# Access Compliance Report

## Public Rights-of-Way

### (Curb Ramps)

Intersection ID: 42943	Main Street: LONG_PAW_LN	Cross Street: SONOMA_VALLEY_DR	Location: S
ADA ID: C0BE6006A298	Ramp Type: PerpDiag	Initial Pass/Fail: Fail	Overall Compliance: No
Severity Score: 8.75			
Codes/Mitigation Info/Possible Solution		Field Measurements/Component Compliance

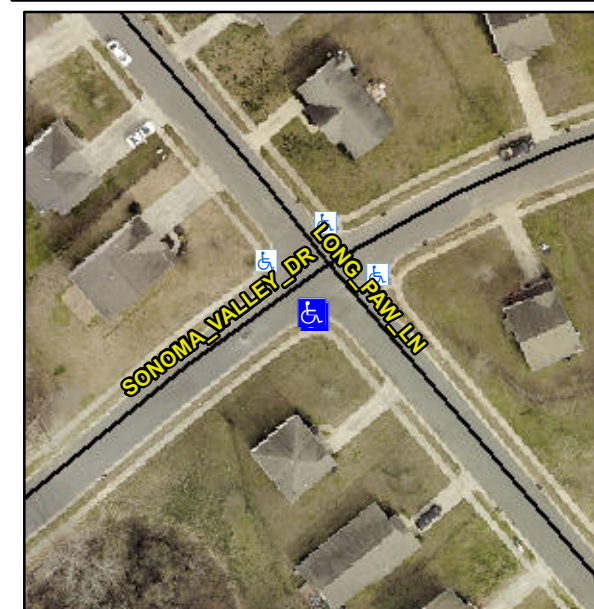
**Not Found, R304.5.1**

Compliance	Description	Data	Compliance	Description	Data
N/A	Ramp Length (in)	48.0	Yes	Ramp Slope (%)	7.6
No	Ramp Width (in)	40.0	Yes	Ramp XSlope (%)	1.0
N/A	Flare Type LT	N/A	N/A	Flare Type RT	N/A
N/A	Flare Slope LT (%)	N/A	N/A	Flare Slope RT (%)	N/A
N/A	Flare Traversable LT?	N/A	N/A	Flare Traversable RT?	N/A
N/A	Landing Length (in)	N/A	N/A	DWS Provided?	N/A
N/A	Landing Width (in)	N/A	N/A	DWS Contrast?	N/A
N/A	Landing Slope (%)	N/A	N/A	DWS Length (in)	N/A
N/A	Landing X Slope (%)	N/A	N/A	DWS Full Width?	N/A
N/A	Landing Curb? (Y/N)	N/A	N/A	DWS Offset (in)	N/A
N/A	Shared Landing?	N/A			
N/A	Gutter Ponding?	N/A	N/A	Gutter Slope (%)	N/A
N/A	Gutter Lip Ht (in)	N/A	N/A	Gutter X Slope (%)	N/A
N/A	Painted X Walk1?	No	N/A	Painted X Walk2?	No
	X Walk 1 Direction	To NE		X Walk 2 Direction	To NW
N/A	X Walk 1 Width (in)	N/A	N/A	X Walk 2 Width (in)	N/A
	X Walk 1 Slope (%)	0.9		X Walk 2 Slope (%)	1.3
	X Walk 1 X Slope (%)	0.7		X Walk 2 X Slope (%)	0.0

**Remove & Replace Curb Ramp With Two New Directional Ramps or Equivalent.**
